SUNSHINE COAST REGIONAL DISTRICT

Question and Answers #1

Request for Proposal No. 2536601

Reservoir Replacement – Dogwood

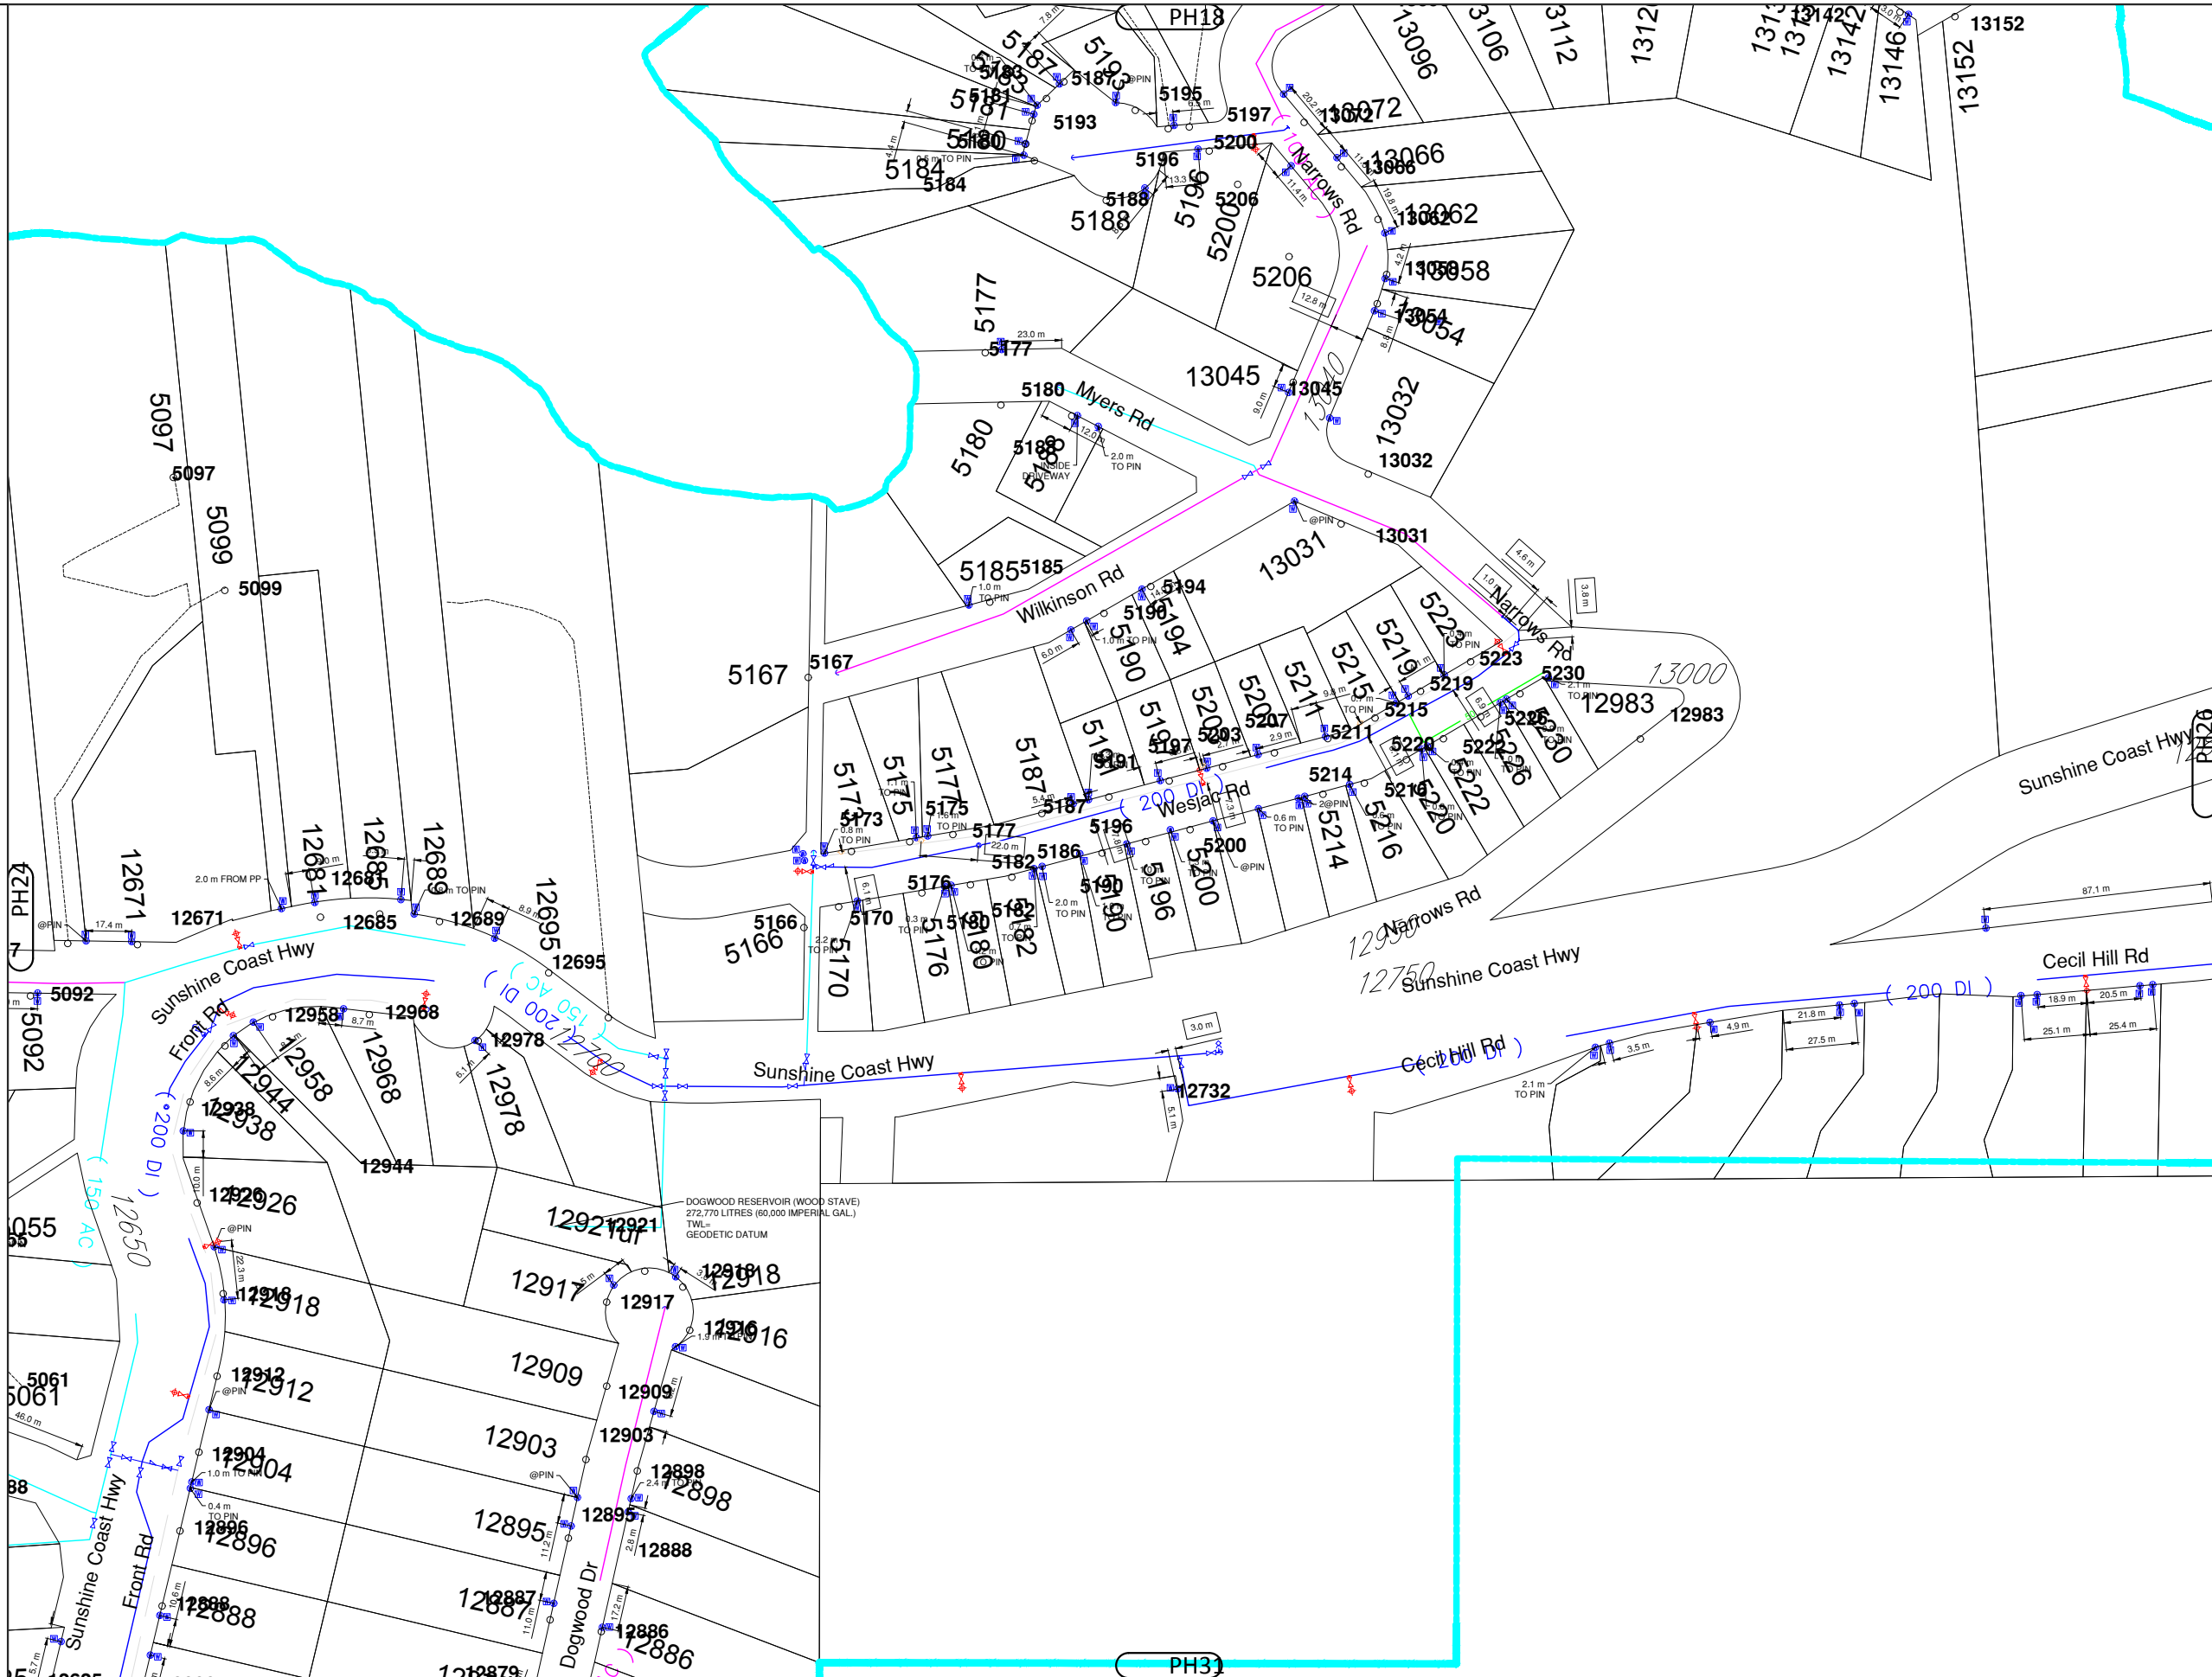
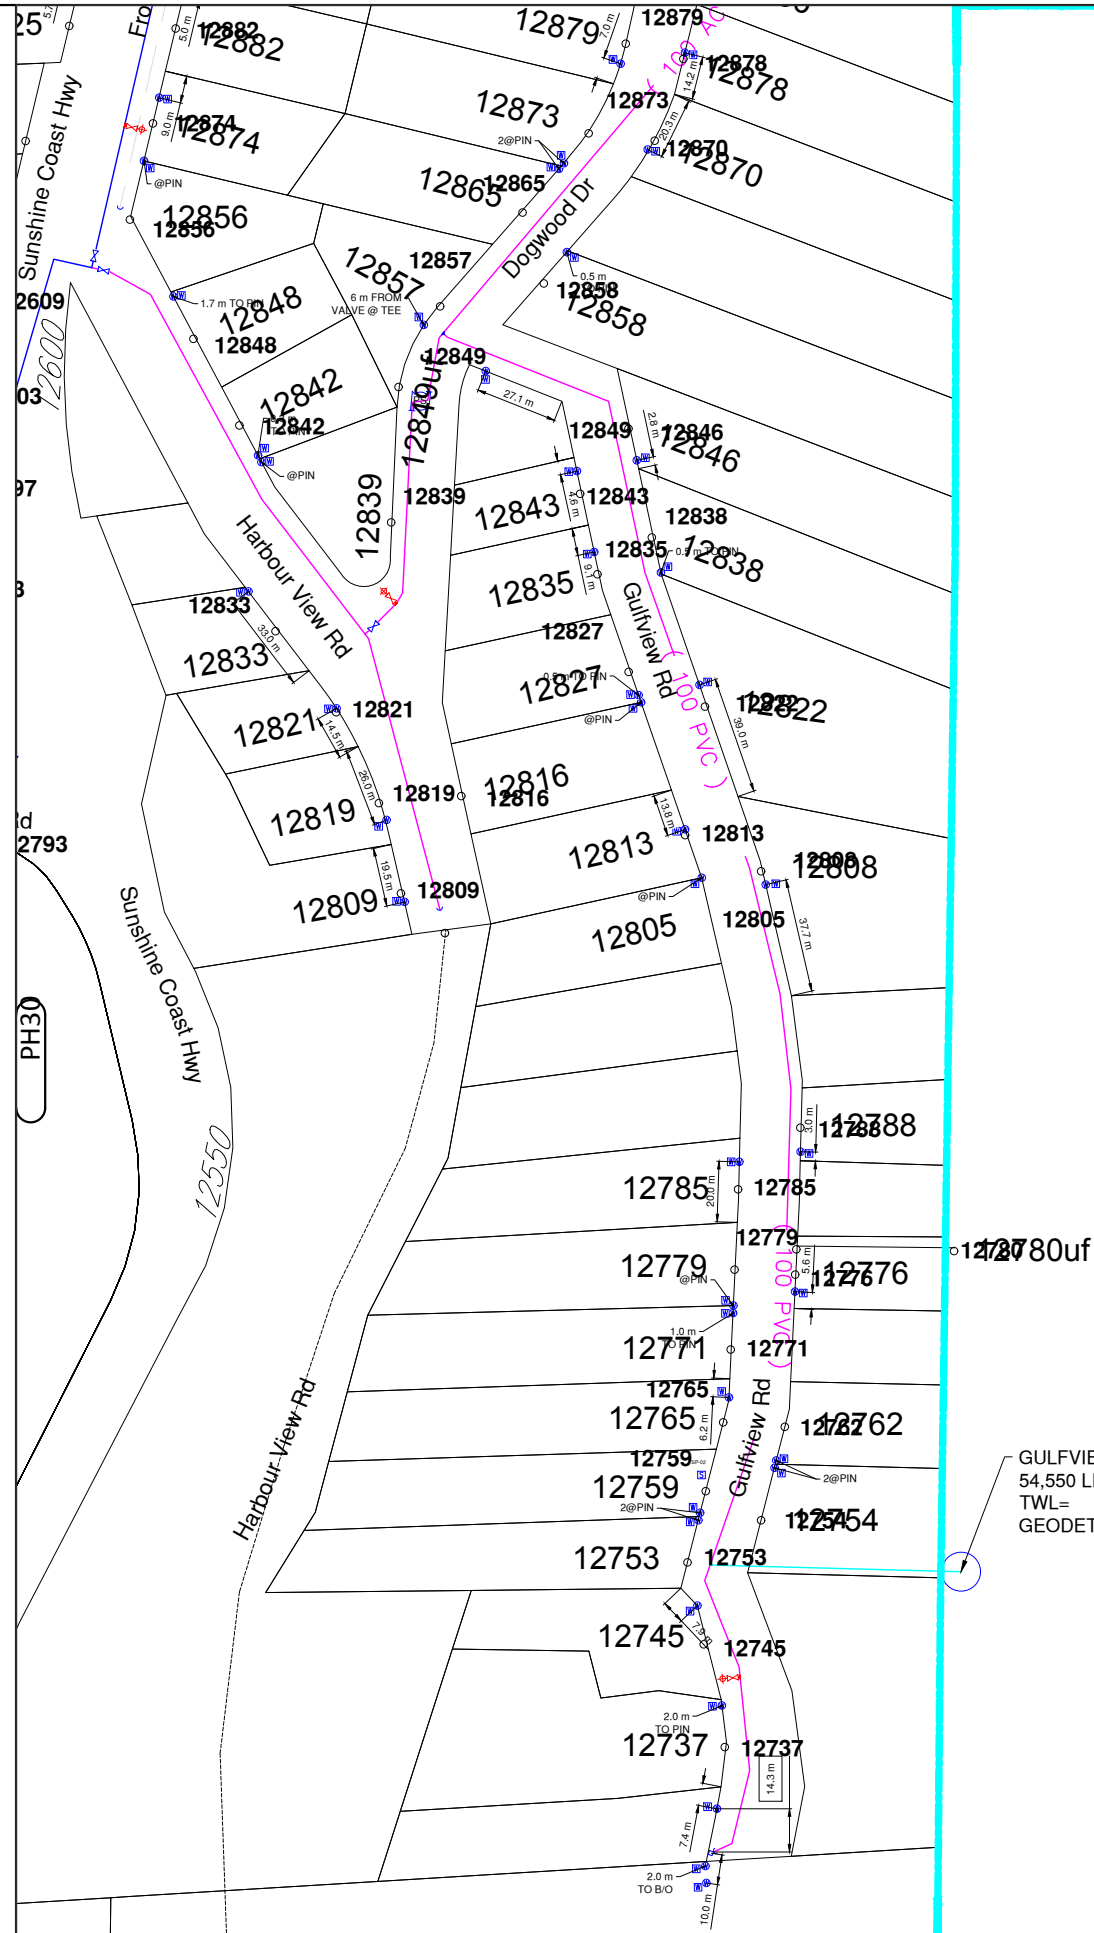
Question: Could you provide a map or diagram showing the existing pressure zones and which zones are serviced by the current reservoirs? If the new reservoir is intended to serve the same zones as the existing floating reservoir, please confirm this.

Answer: Attached to this Q&A we have included the pressure zones in South Pender Harbour Water System which include Cecil Hill (118 m), South Pender Harbour (123 m), and Gulfview (152 m).
